Amendment Notice 2

Licence Number	L8103/1989/3
Licence Holder	Aragon Resources Pty Ltd
ACN	114 714 662
File Number:	2013/001965
Premises	Fortnum Gold Mine Mining Tenements – M52/6, M52/95, M52/96, M52/98, M52/99, M52/132, M52/133
Date of Amendment	5 October 2018

Amendment

Figure 1 Plan of Premises

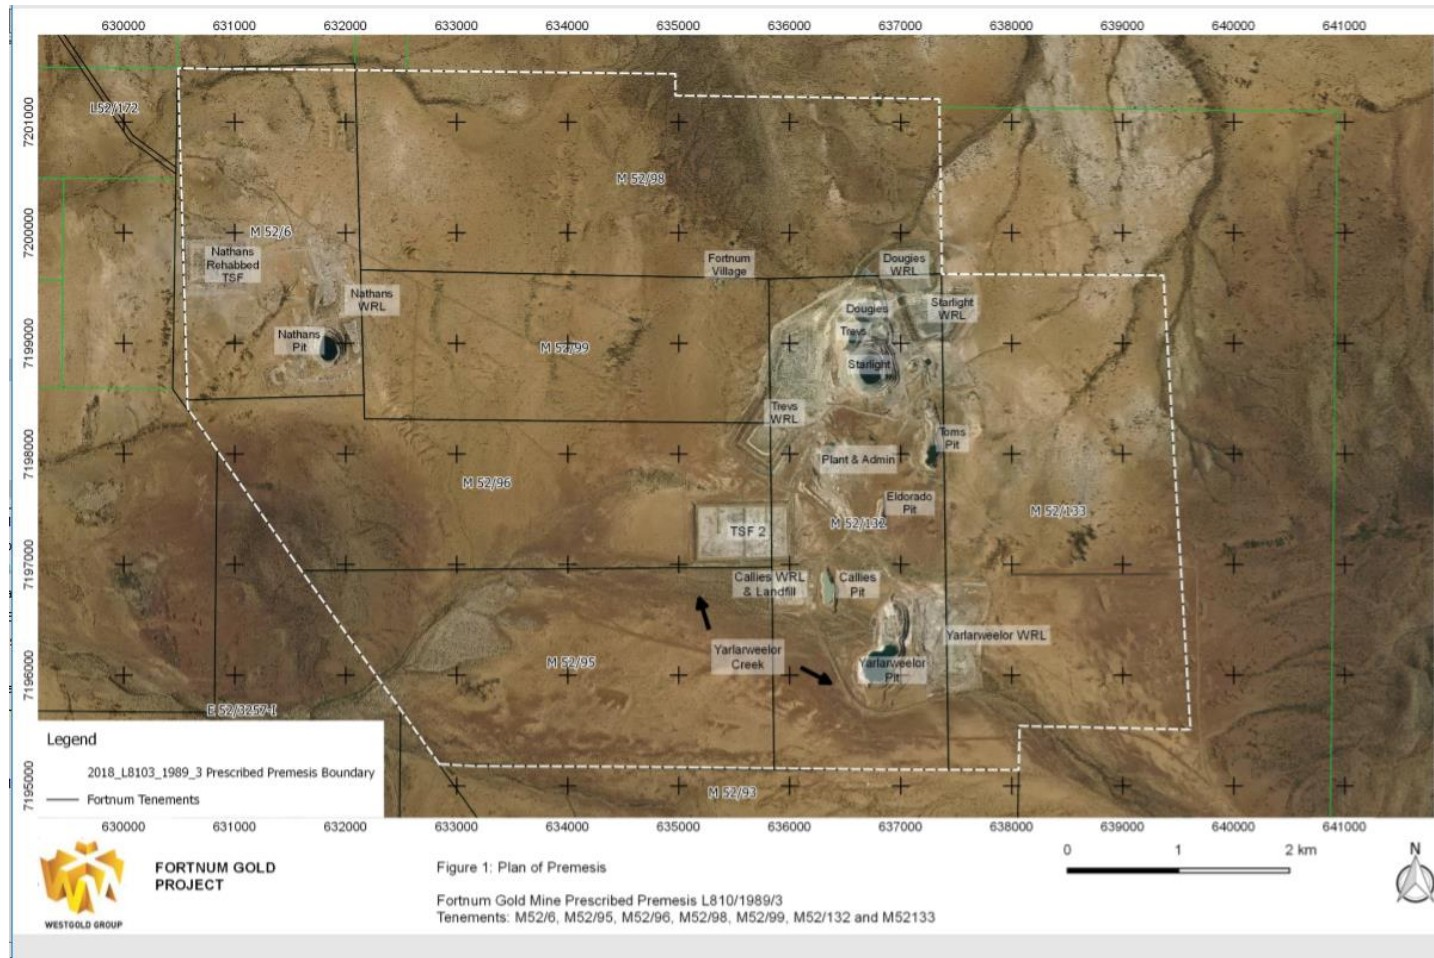
1. **Attachment 3** of the Licence, “Plan of Premises” is replaced with Figure 1 of this Amendment notice as detailed below.

Figure 2 Dewater pipeline and discharge locations (Tom's, Starlight, Callie's South, Eldorado and Trev's Pits)

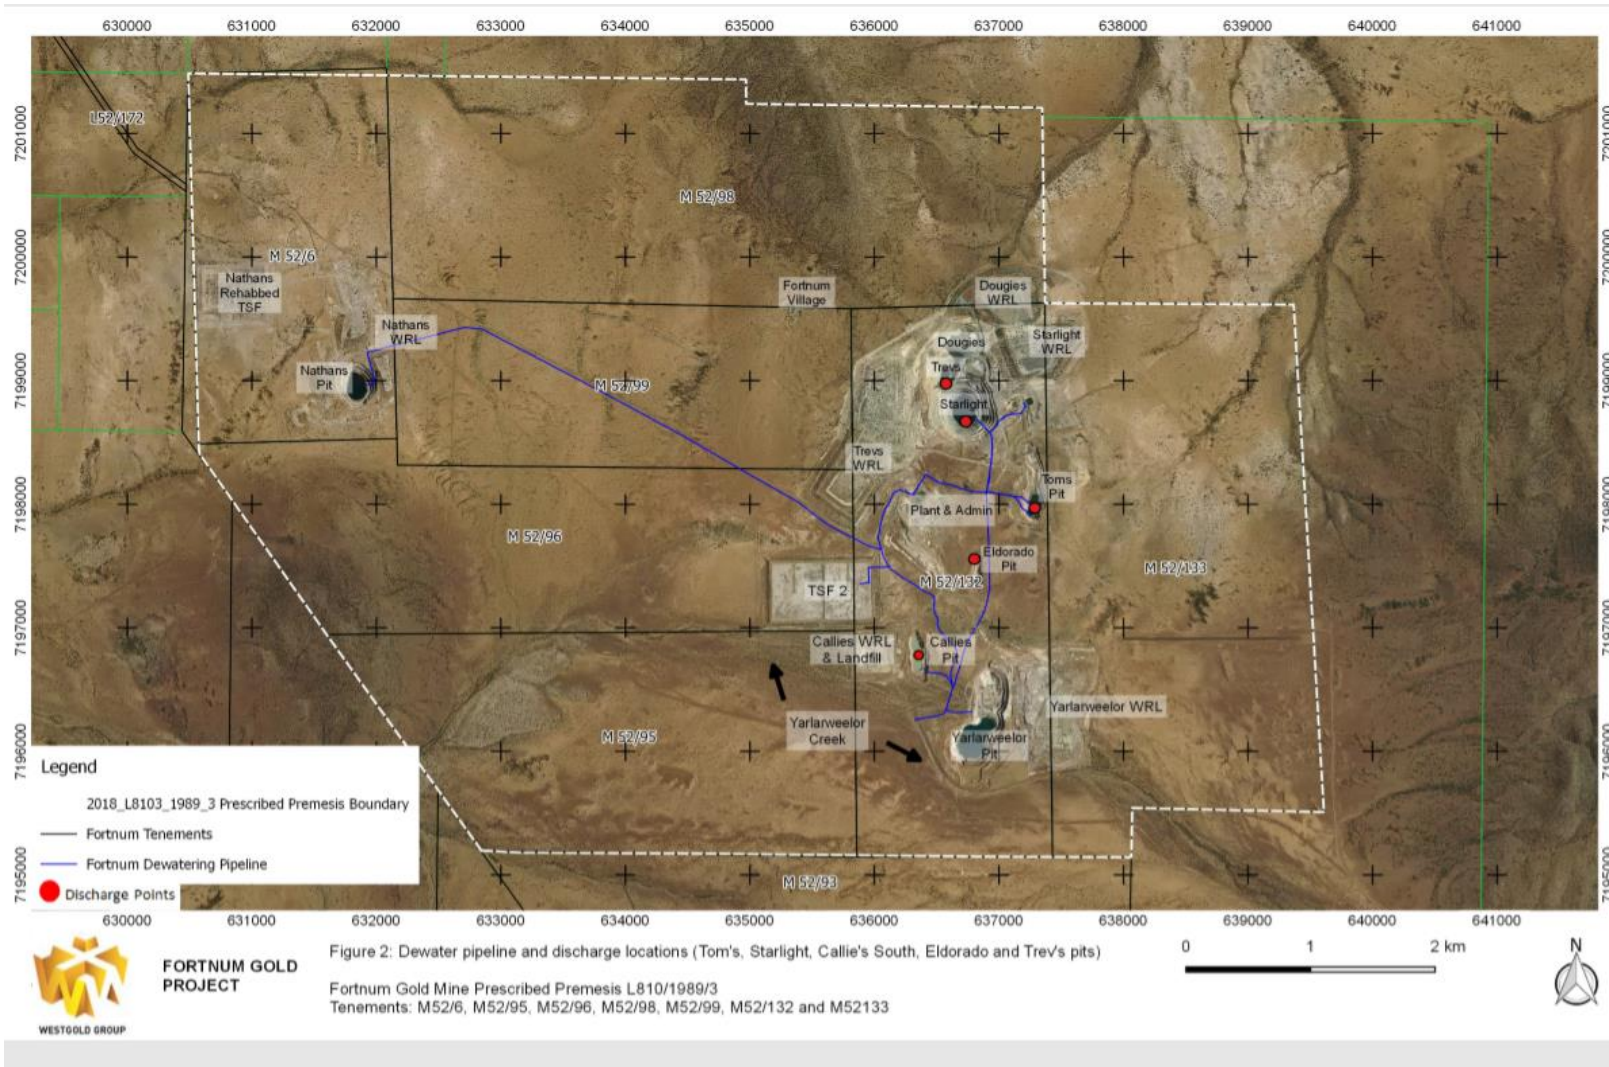
5. Attachment 4 of the Licence is replaced with Figure 2 of this amendment notice as detailed below.
